**UNITED STATES  
NUCLEAR REGULATORY COMMISSION**

**SUBJECT: DAVIS-BESSE NUCLEAR POWER STATION - INSPECTION TO EVALUATE THE ROOT CAUSE EVALUATION AND CORRECTIVE ACTIONS FOR CRACKING IN THE REINFORCED CONCRETE SHIELD BUILDING OF THE CONTAINMENT SYSTEM 05000346/2012009(DRS)**

Report No: 05000346/2012009

Picture No. 4 – Davis-Besse Shield Building Impulse Response Testing Mobility Plot

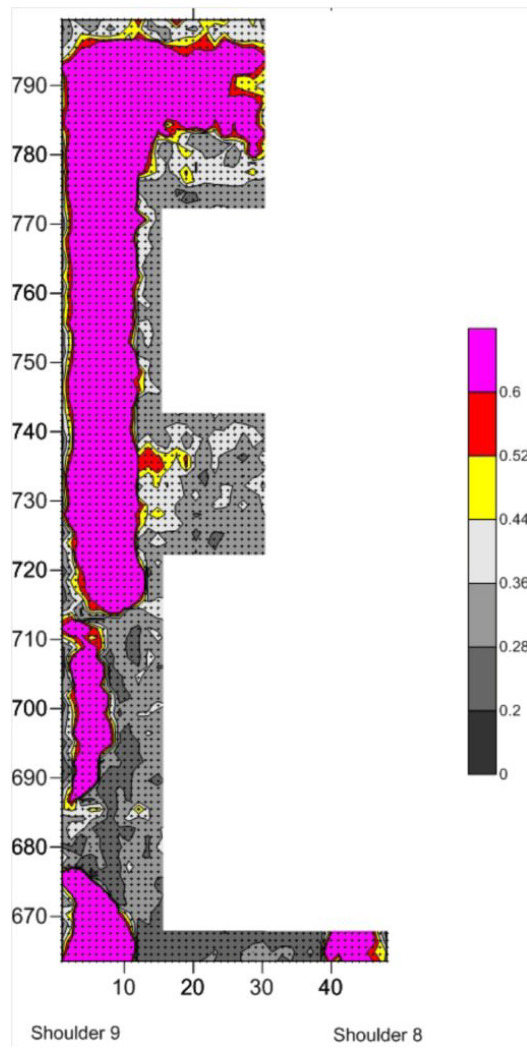
- The NRC team reviewed the IR mapping results (Attachment 2, Pictures 4 and 5) and SB drawings identifying the location and configuration of structural reinforcement (e.g., rebar) to determine if the extent of laminar cracking identified was consistent with the RCT conclusions that SB reinforcement design features contributed to the extent of cracking observed. The NRC team confirmed that the extent of cracking identified by IR testing results was consistent with the RCT identified Contributing Causes. However, the NRC team identified areas of laminar crack indications between SB shoulders 6 and 7 and above the mainstem line penetrations which did not include sufficient IR test locations to link this area directly with cracked areas in the adjacent SB shoulder regions. The NRC team's observation related to a lack of IR coverage did not invalidate the theory for the Direct Cause of the cracking or the Contributing Causes because the extensive computer modeling and vendor CBS testing provided a sufficient basis to validate these causes. Specifically, five analyses were completed in support of the SB laminar cracking causes Freezing Failure and Rebar Spacing Sensitivity Study, Structural and Thermal Analysis Investigation, Stress State During 1978 and 1977 Blizzards, Stress Analysis Due to 105 mph Wind Load, and Laminar Cracking Due to 1978 Blizzard. Therefore, the NRC team concluded that the RCT had developed a sufficient basis for the Contributing Causes.

Picture No. 10 – Davis-Besse Shield Building – Water Migration

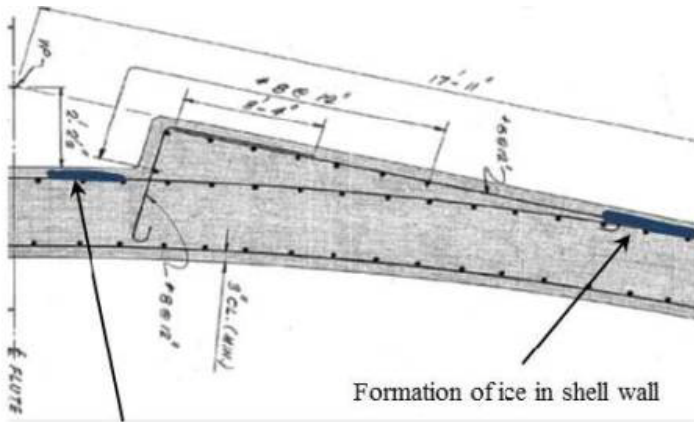
- The NRC team confirmed that weather records existed which supported the Direct Cause related to the extreme environmental conditions associated with the blizzard of 1978. This blizzard occurred from January 25 – 27, 1978, and produced rain with sustained winds, followed by rapid temperature drop and significant snowfall. Specifically, snowfall amounts ranging from 12 inches in Toledo to 22 inches at Saginaw, Michigan were recorded with wind speeds of 45 miles per hour (mph) and gusts to 105 mph west of Toledo, Ohio. This blizzard was preceded by a rapid drop in temperature beginning at 12 noon on January 25, 1978, and ending at midnight January 27, 1978. The vendor report included temperature maps that record a temperature drop from 40 degrees Fahrenheit (°F) at about 6:00 pm on January 25, 1978, to about -5° F by midnight. Daily temperatures were below 20° F by noon on January 26, 1978, and surface temperature continued to drop to near 0° F by midnight on January 27, 1978. These environmental conditions enabled moisture to penetrate the SB concrete, freeze and expand, which created a radial stress that exceeded the tensile strength of the concrete triggering the subsurface laminar cracking (Attachment 2, Pictures 10, 11 and 12).

Picture No. 11 – Davis-Besse Shield Building – Location/Progression of Ice Formation

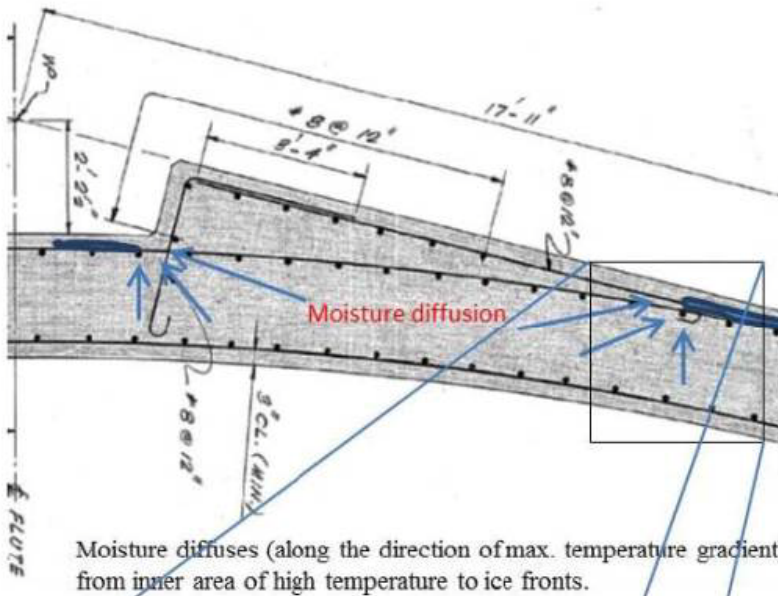
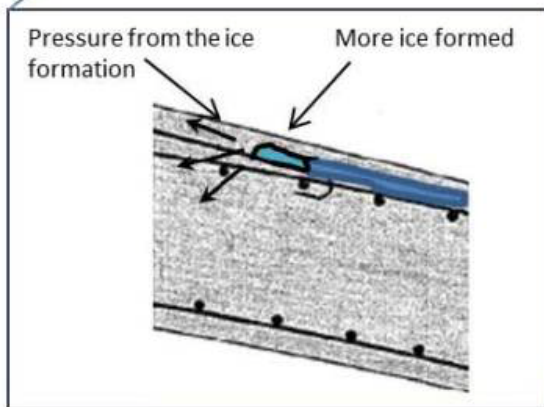
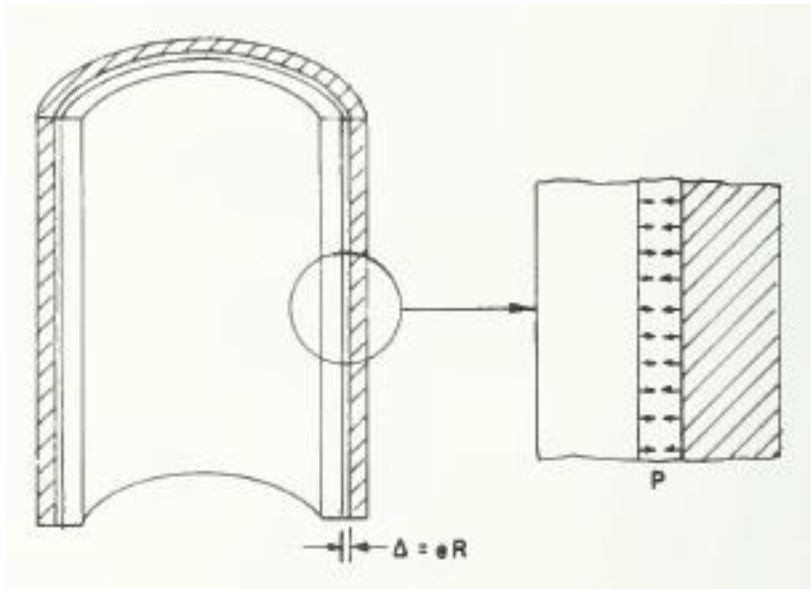
The RCT concluded that the Direct Cause for the SB concrete laminar cracking was the integrated affect of moisture content, wind speed, temperature, and the duration of these conditions created during the blizzard of 1978. The environmental conditions created by the blizzard of 1978 enabled moisture to penetrate the SB concrete, freeze and expand, which created radial stresses that exceeded the tensile strength of the concrete and initiated the subsurface laminar cracking (Attachment 2, Picture 11).
